United States
Department of Defense

Independent Engineering Assessment of
the Army's Transportation Plan for
the BRAC Recommendation #133 Project
Fort Belvoir - Mark Center, Virginia.

SUBJECT: Independent Engineering Assessment of the Army's Transportation Plan for BRAC Recommendation #133 Project Fort Belvoir - Mark Center, Virginia, (Report No. DODIG-2012-024)

Figure 4-2: Locations of Recommended Analysis Intersections

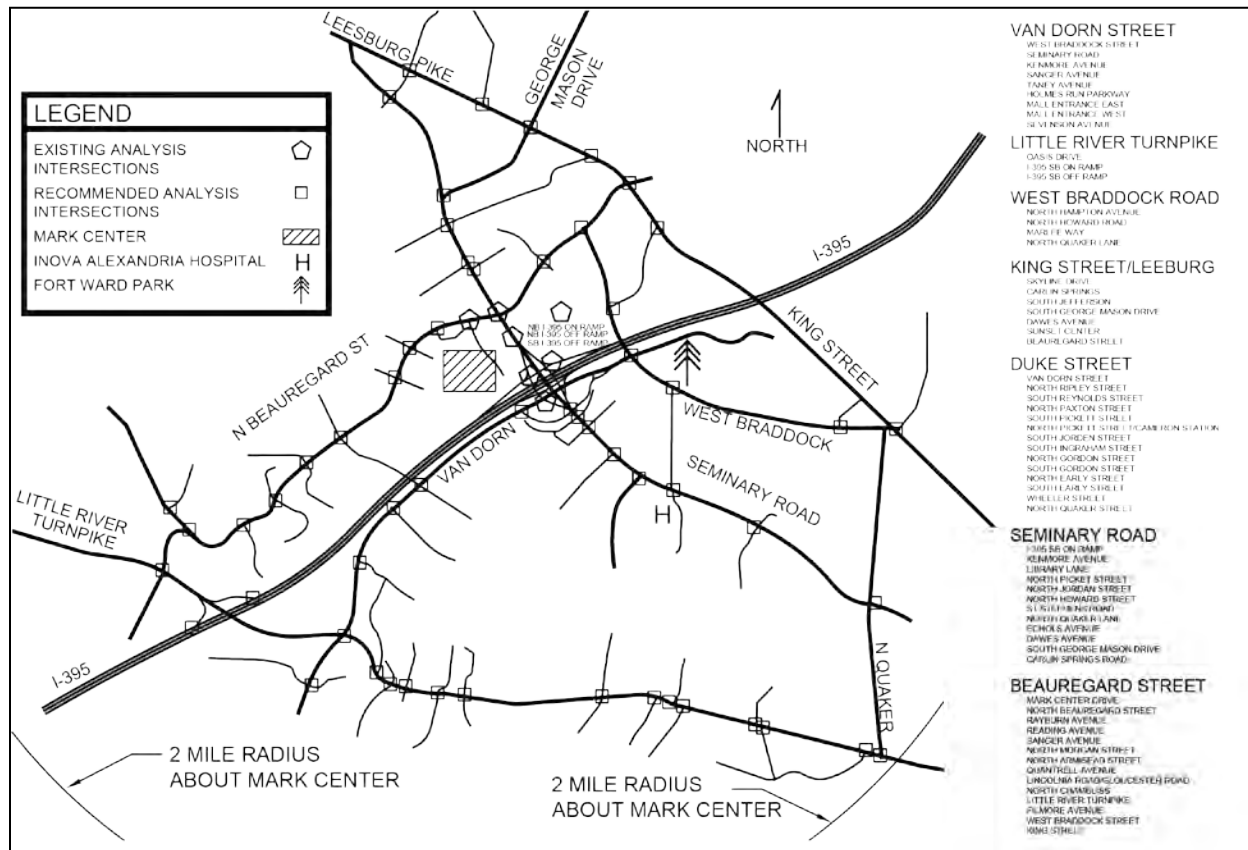
- Study Area – The Transportation Plan fails to evaluate the project impact at all signalized intersections within a two-mile radius and all un-signalized intersections within a one-mile radius.^{2B} (ITE Recommended Practice, Table 2-3, pg. 10)

A map illustrating the location of these intersections and the two-mile radius is shown in Figure 4-2.

Figure 4-3: Independent Evaluation of the Roundabout

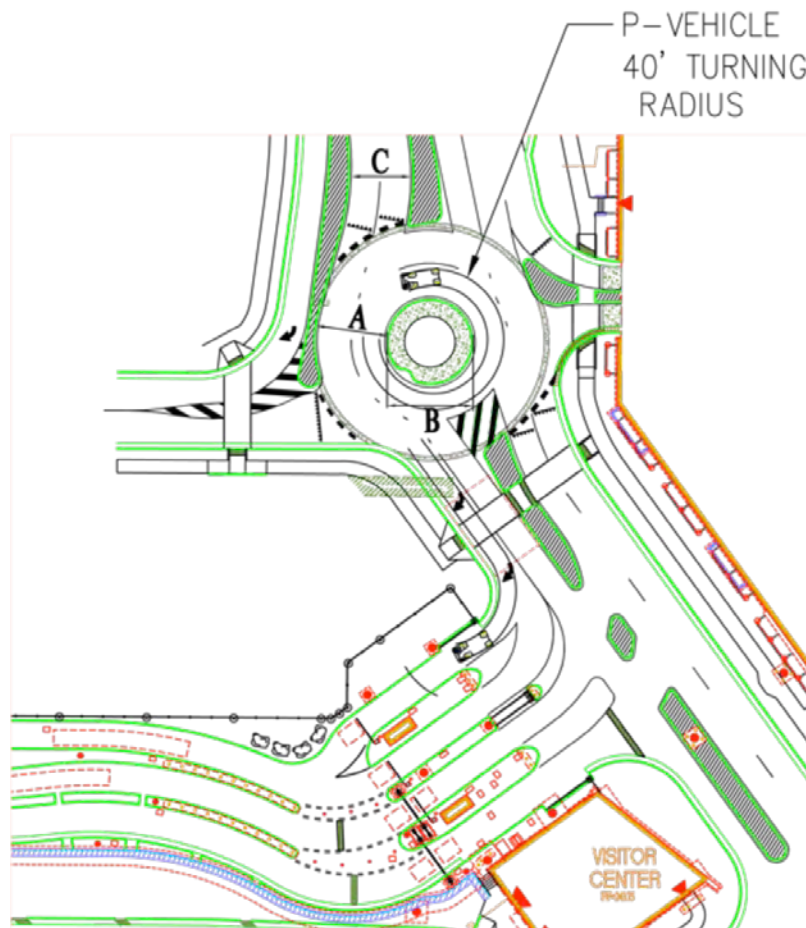
The SAMS assessment report also showed the deficiencies of the roundabout in the “Table 4-2 *Summary of Critical Roundabout Design Features*” and “Figure 4-3: *Independent Evaluation of the Roundabout*.” The SAMS assessment report further stated, “according to the WSDOT Design Manual, small changes in geometry can result in substantial changes in operational performance.”

As shown in Figure 4-3 below, the roundabout was not designed consistent with standard design practice for roundabouts. The dimensions of the roundabout are not sufficient to provide efficient traffic flow through the roundabout and into the North and South Parking Garages as well as IDA Drive. These design deficiencies will result in inefficient circulation and unnecessary congestion.

As shown in Figure 4-3, the proposed WHS Circle roundabout is deficient in all the pertinent design parameters. According to the WSDOT Design Manual⁷, small changes in geometry can result in substantial changes in operational performance.

It is recommended that the designer revisit the design of the roundabout and make necessary changes to improve operational performance which will maximize gate processing operations and overall traffic circulation on WHS Circle.

Figure 4-6: Locations of Observed Pedestrian Service Deficiencies²

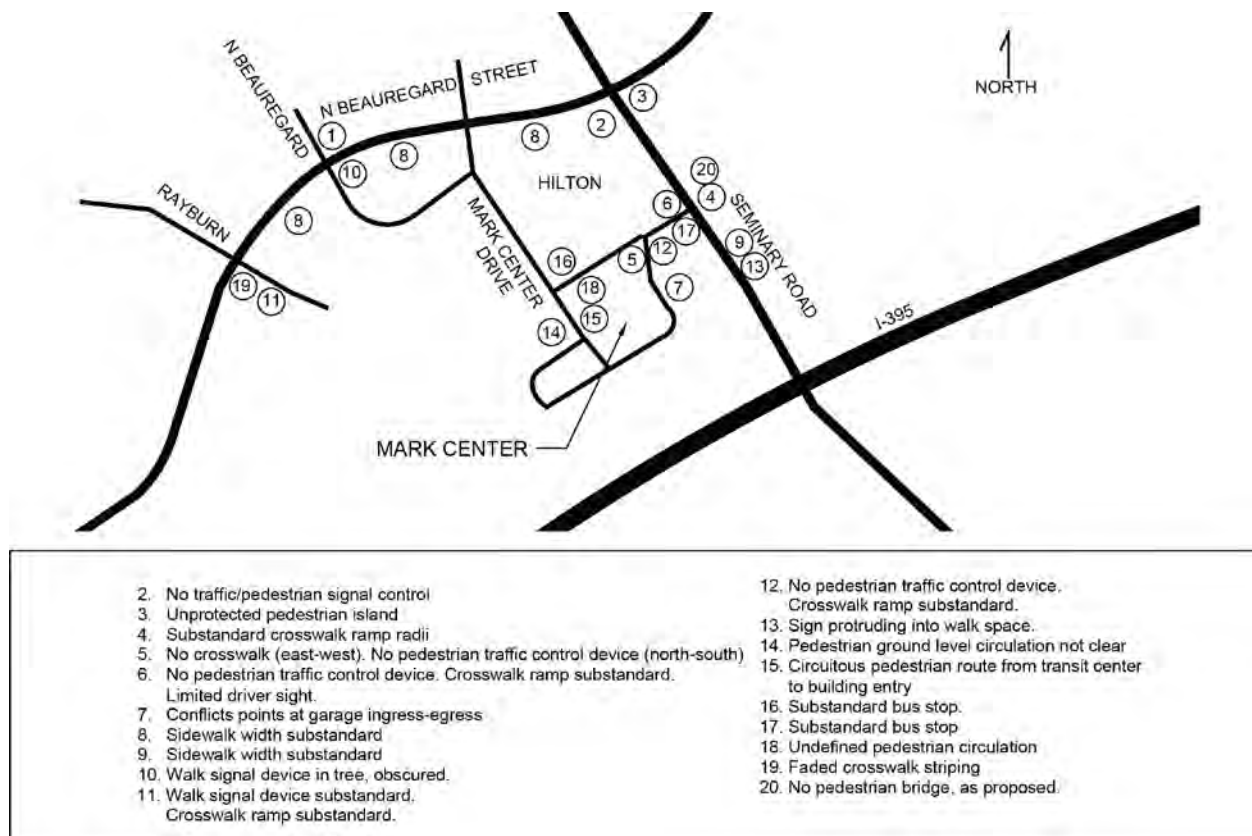
The deficient locations observed on the road network at and near the site are identified in Figure 4-6 below. Written descriptions of these locations is presented in the Appendix B: Table B-1: Pedestrian Service Field Observations At and Near the site of BRAC 133 Project Fort Belvoir – Mark Center, Virginia.

The findings that the pedestrian facilities in and around the BRAC 133 facility are unsafe and ADA-deficient are incorrect. Due to the weight that a finding of "ADA-deficient" carries, the Army requests that this inaccurate characterization be deleted from the final report. Each item in Figure 4-6, found on page 72 of the Independent Engineering Assessment and titled "Locations of Observed Pedestrian Service Deficiencies" is addressed here:

- 1- Item listed on figure 4-6 but not discussed in commentary
- 2- Please note the pedestrian control devices noted in the photograph (fig. 2)
- 3- Please note the 6" protective curbing in the photograph (fig. 3)
